AGENDA: TSC 6/2/14

Consider request to mark and sign a CROSSWALK across the south leg of the intersection of 18th Street & Naismith Drive.

MINUTES: TSC 6/2/14

Subject: Request for crosswalk at Naismith & 18th **Attachments:** Naismith & 18th crosswalk request.jpg

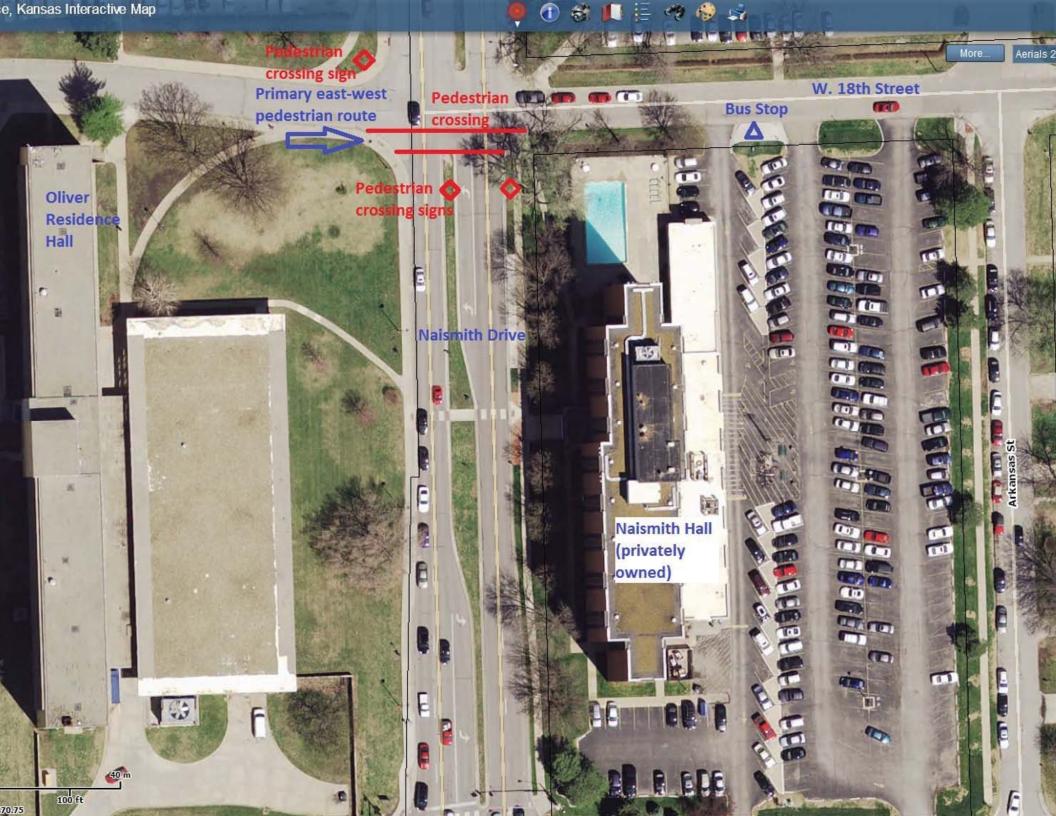
On behalf of the University of Kansas, I respectfully request your favorable consideration of our proposal to install a signed and marked crosswalk on the south leg of the intersection of Naismith Drive & W. 18th Street. I've attached a sketch of the proposal.

- High volumes of pedestrians cross at this location between Oliver Residence Hall and points east
 including the aforementioned bus stop, a large parking lot on the northeast corner of this intersection,
 the student recreation center at the northeast corner of 18th & Missouri, etc. The 2012 Lawrence Bike
 Count tallied averages of 849 bicycle and pedestrian trips in this block daily (over 25,000 monthly and
 over 300,000 annually); it did not indicate how many cross at this location but we anticipate it would
 be a significant percentage.

- While there are already marked crosswalks mid-block on Naismith Drive between 19th and 18th
 Streets, and across Naismith at 19th, those crosswalks are not on a direct route between Oliver
 Residence Hall and points east, and pedestrians ordinarily do not go out of their way to use a marked
 crosswalk a half-block or whole-block away, which in this case would add at least one block of walking
 distance if pedestrians self-diverted to the mid-block crossing.

- The east and west approaches to the intersection of Naismith & 18th are stop-controlled, while vehicular traffic on Naismith Drive is not stop or yield controlled at this intersection, increasing the risk for pedestrians crossing Naismith.

- The east and west approaches to this intersection are two lanes wide, while Naismith Drive is four lanes wide with a narrow median, again increasing the risk for pedestrians crossing Naismith.

MOTION BY COMMISSIONER ZIEGELMEYER, SECOND BY COMMISSIONER DEVLIN, TO RECOMMEND THAT THE UNIVERSITY OF KANSAS BE PERMITTED TO MARK AND SIGN A CROSSWALK ACROSS THE SOUTH LEG OF THE INTERSECTION OF 18TH STREET & NAISMITH DRIVE; THE MOTION CARRIED, 8-0.

Figure 4. Pedestrian crash rate vs. type of crossing.

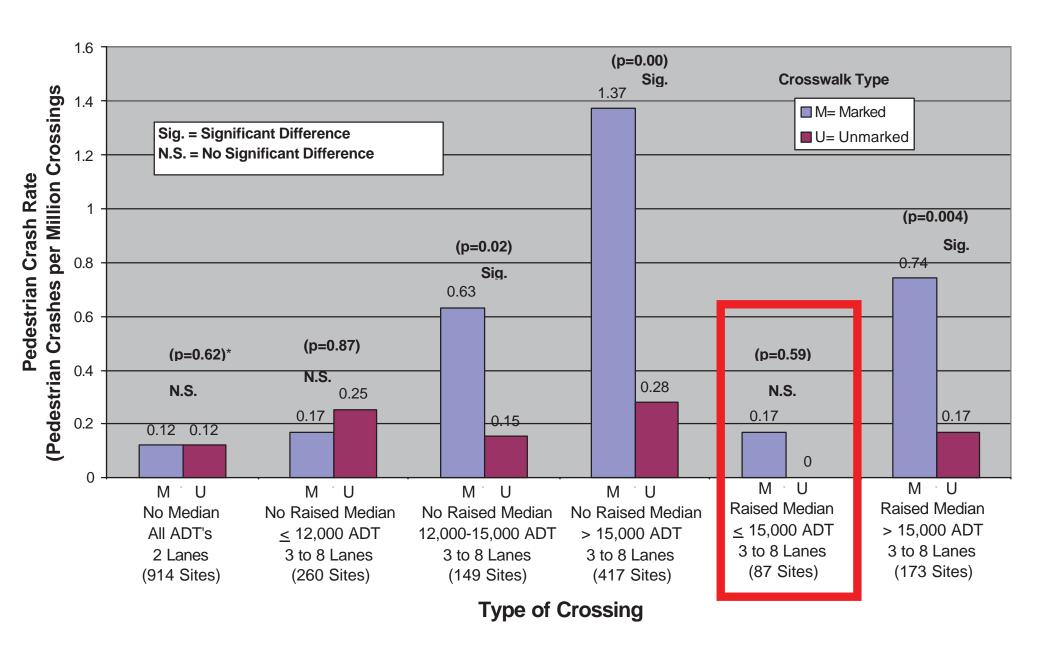
- 1. Inasmuch as there are paved sidewalks and sidewalk ramps on both sides of Naismith, this location is classified as an "un-marked crosswalk" by state law.
- 2. A nation-wide study of pedestrian crash rates at this type of location (raised median, ≤15,000ADT, and 3-8 lanes) found no significant difference in crash rates at marked crosswalks when compared to unmarked crosswalks.
- 3. If the request is approved, it is recommended that the University of Kansas be responsible for the installation and maintenance of the appropriate traffic control signs and markings.
